METER

■ COMBINATION METER

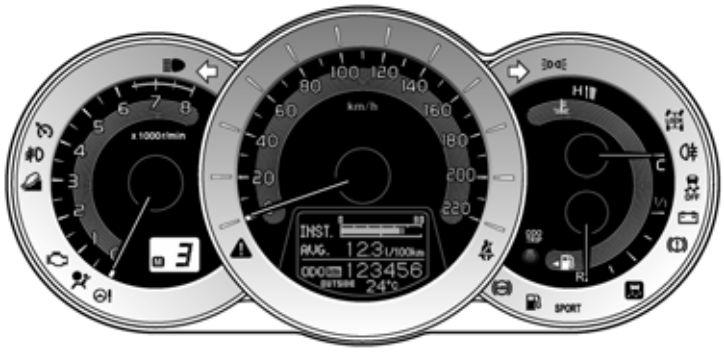
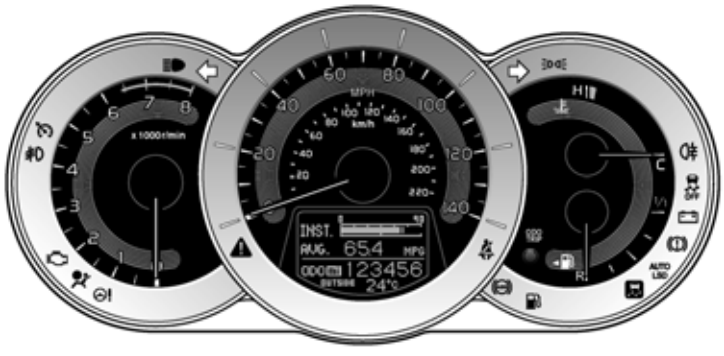
- The design of the combination meter has been changed.
- A shift position and shift range indicator and a SPORT indicator light are provided on models with Continuously Variable Transmission (CVT).
- The DISP switch has been relocated to the steering pad.
- The following indicator lights have been changed:

Indicator Light \ Model	New	Previous
Power Steering Warning	 10SBE41Y	P/S 10SBE46Y
Slip	 10SBE42Y	 10SBE47Y
Cruise Main	 01NBE150Y	CRUISE 10SBE48Y
AUTO LSD	AUTO LSD 01NBE147Y	—
VSC OFF	 01NBE151Y	—
SPORT	SPORT 01NBE152Y	—
